To all holders of Ordnance Pamphlet 925
Change 1 is to be filed with OP 925.
Approved by The Chief of The Bureau of Ordnance

OP 925 CHANGE 1

Add information contained herein to OP 925.

MK 51 Mod. 7 Bomb Rack Outaway View

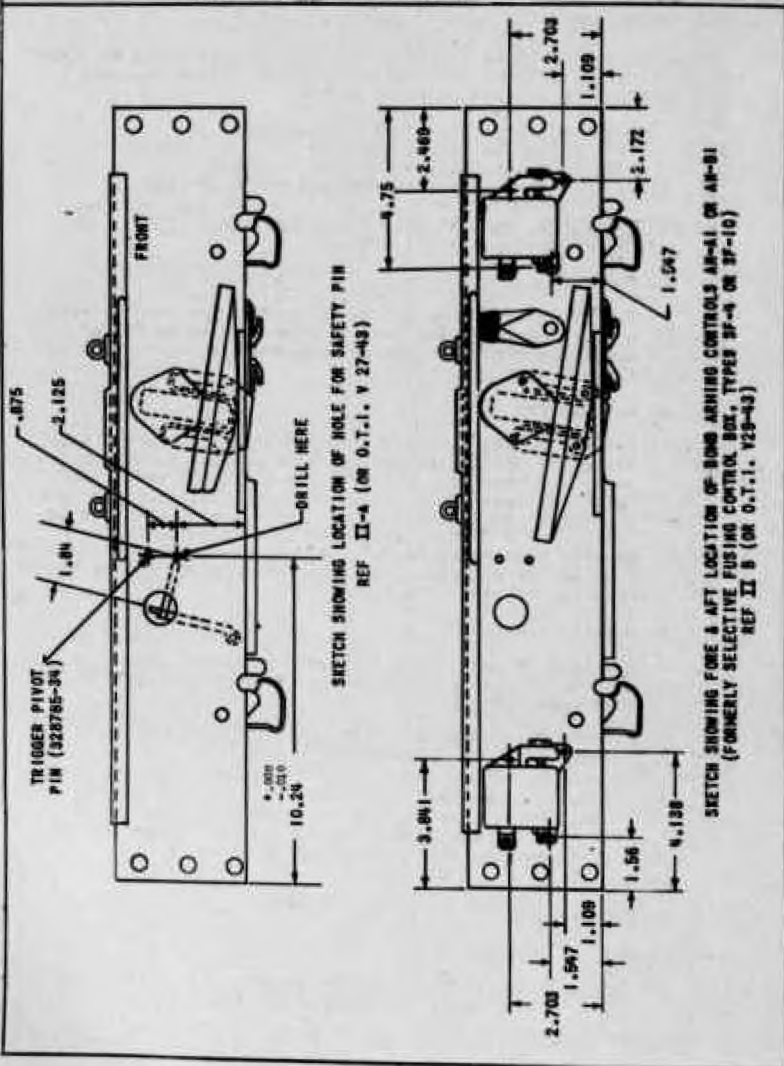
The purpose of this OTI is to provide the service with a means of rendering Mark 51 Type Bomb Racks "Safe" against accidental release when the airplane is not in flight.

Location of hole. The following procedure should be used to find the exact location for drilling the .257" hole. (See sheet 12)

- a. From the after end of the side plate of the rack, measure 10.24" forward.
- b. From the lower edge of the side plate, measure 2.125" upward. As shown on figure, this locates the hole immediately aft the stirrup, making it possible to insert a "Safety Pin" tangent to the forward end of the stirrup, thus preventing release.

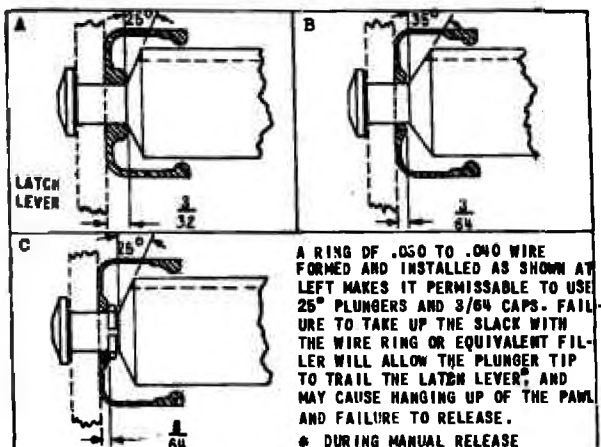
- d. Use of thick-bead caps and thin-bead caps. First low-temperature caps had 3/64 (thin) beads. Then a quantity of 3/32 (thick) bead caps were made. All 3/32 bead caps are of low temperature composition, but they are for use only when the release solenoid plunger (BuOrd 328772-9) has an angle of 25 deg. as shown below. The thick-bead caps (and 25 deg. plungers) were ruled out by Bu Ord for future production. Present low temperature caps have the 3/64 (thin) beads and are distinguished from the original non-low-temperature caps by a colored dot (either of aluminum paint or of pigment molded into the rubber). The sketches below show the combinations of caps and plungers which may satisfactorily be used on the MK 51.

The MK 50 rack release unit has an .015 thicker latch lever, which will effect the clearances when the combinations shown are used.

Figures A and C show infrequent combinations that may be found. Fig. B shows the normal combination. All Mod 8 and 9 racks have this arrangement, and in addition, they are fitted with an .010 beeking washer. See section VIIB5.

FIELD REVISIONS
INSTALLATION, GROUND-CHECKING PIN

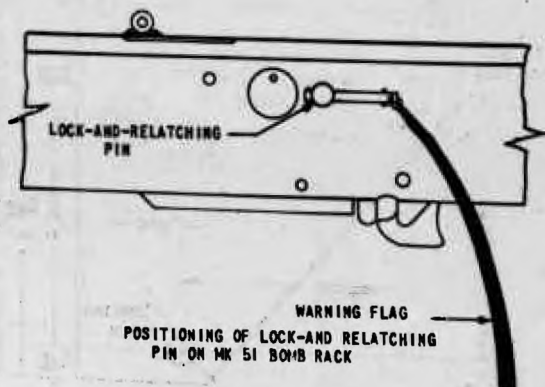
- a. Manufacture a drilling template in accordance with the details as shown on sheet 33 (One drilling template should be sufficient to drill all racks being modified.)
- b. Clamp drilling template against side plate of bomb rack, using C-clamp or vice (position template as shown on sheet 34.
- c. Drill a 1/4" pilot hole through adjacent side plate of rack.
- d. Shift template to opposite side of rack and repeat

- (5) Reposition the release assembly and secure in place with the parts removed in steps (1) and (2) above.
- g. Manufacture lock and re latch pins in accordance with the details as shown on sheet 33. A warning flag should be attached to each pin handle so as to be easily seen from below the rack and the bomb.

VI
 MANUAL CABLE MOVEMENTS & FORCES

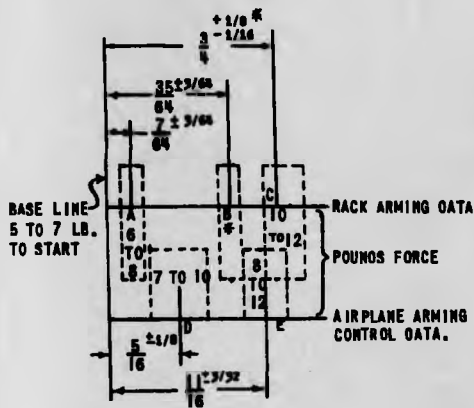
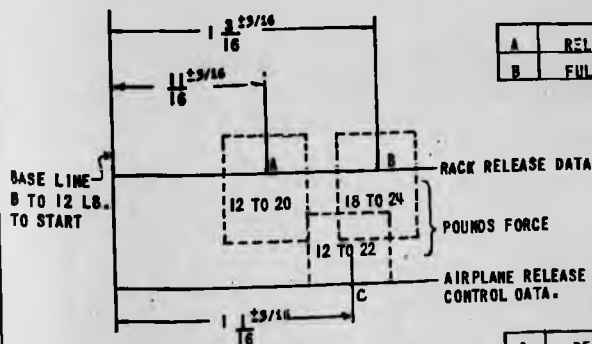
THESE VALUES ARE UP TO DATE AS OF 9/29/44 WHEN TOLERANCE ON "C" (\pm) IN ARMING WAS MADE $+1/8$ IN PLACE OF $+1/16$ AND LOAD ON "E" ($\#$) IN ARMING WAS REMOVED.

Note that this change is only required if the manual cranking force is in excess of that given in the diagram on sheet 71, namely 12 lbs.

RELEASE ASSEMBLY, INCLUDING ADJUSTMENTS

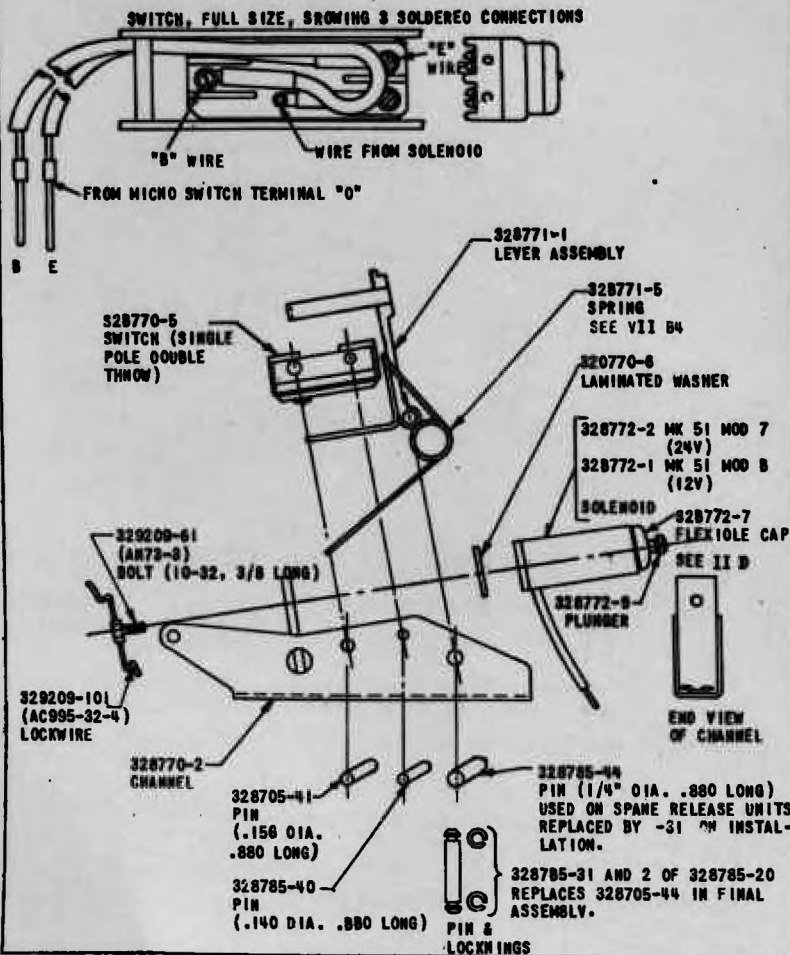
A NEW CAP IS NOW AVAILABLE WHICH IS OF A SYNTHETIC COMPOSITION WHICH RETAINS ITS FLEXIBILITY DOWN TO MINUS 50 DEGREES FAHRENHEIT. ALL OLD CAPS SHOULD BE REPLACED. DIMENSION "A" AND A COLORED SPOT SERVE TO DISTINGUISH NEW CAPS FROM OLD. SEE SECTION [REDACTED] FOR IDENTIFICATION AND INSTALLATION. WHEN INSTALLING CAP KEEP DRAIN HOLE ON SAME SIDE AS SOLENOID LEAD WIRE, THAT IS, DOWN.

VII INDEX TO CHANGES; NOTES ON CHANGES

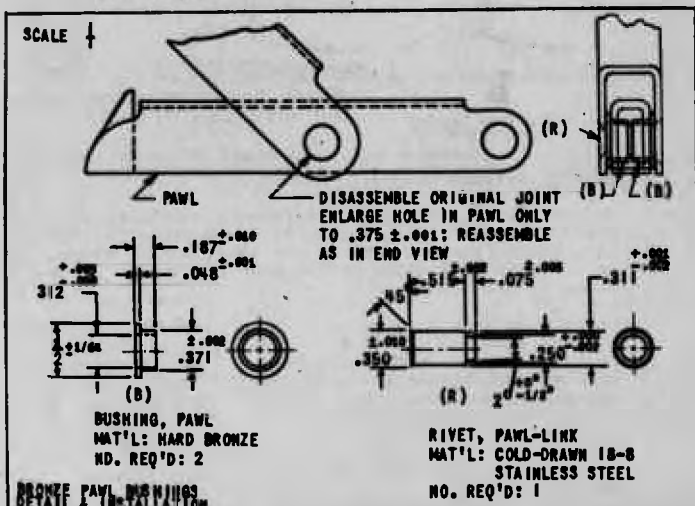
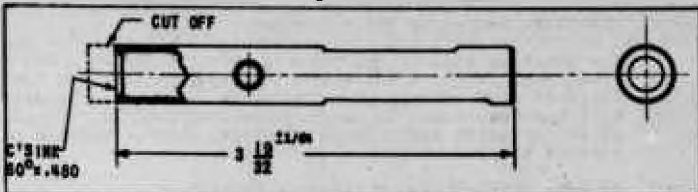
These instructions are given so that stations having facilities can increase the effectiveness of the subject racks. Stations without facilities should turn in racks which can be spared in order that this and the other improvements listed may be made.

The cause of excessive force required to manually arm the rack has been found in some cases to be a misalignment between the brass grommet thru which the cable works, and the arming plunger. The misalignment causes a binding of the manual arming spring 328766-6, which is held in the plunger, and which terminates in the grommet.
